Dublin Cycling Campaign

December 2016

Submission by Dublin Cycling Campaign on the Sandymount to Sutton scheme

Figure 2: Junction integration problem

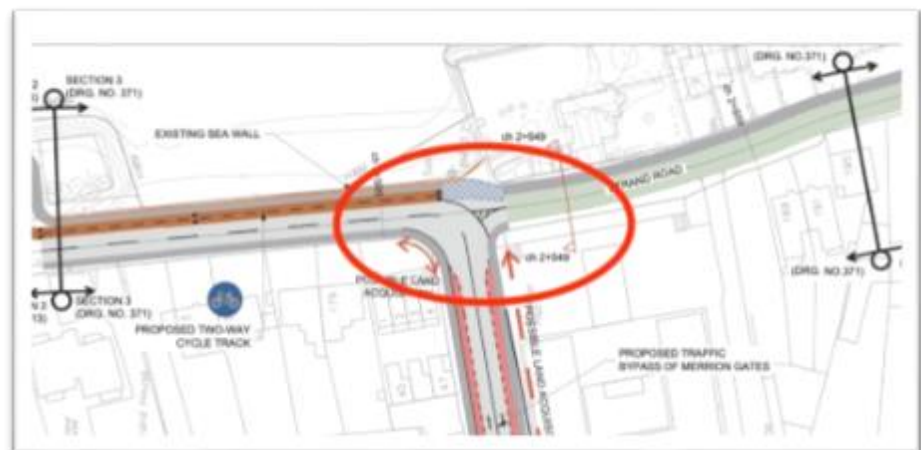
It is not clear in the detailed designs how the cycle tracks will be integrated along the primary route with the 2 way cycle track and the proposed Strand Road / Merrion Road cul de sac. Perhaps ensuring the cul de sac is not a black top road surface

will ensure that driving speeds are very low along with slowing the driving and cycling traffic at the shared space integration point, might relieve serious conflict.

Figure 5: 2 way cycle track showing counter intuitive cycle sides

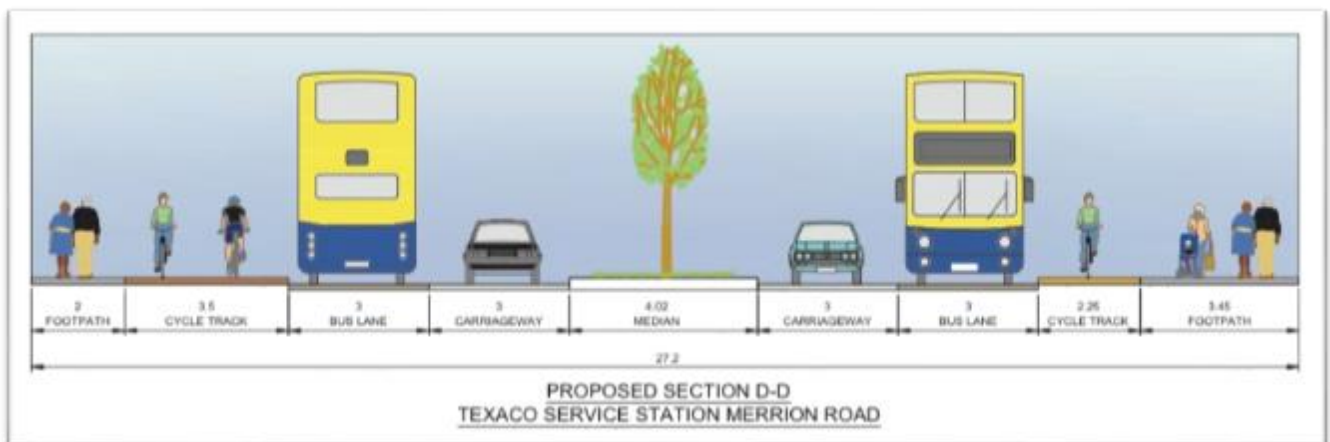
The proposed 2 way cycle track needs to be more distinctly separated from the adjacent roadway to set out cycling on the left more intuitive. The design shows that people are expected to cycle towards each other in opposition to staying to the left, but instead staying on the right. There is ample median that needs to be resized to give much more distinct and safe separation of the cycle track from the roadway.
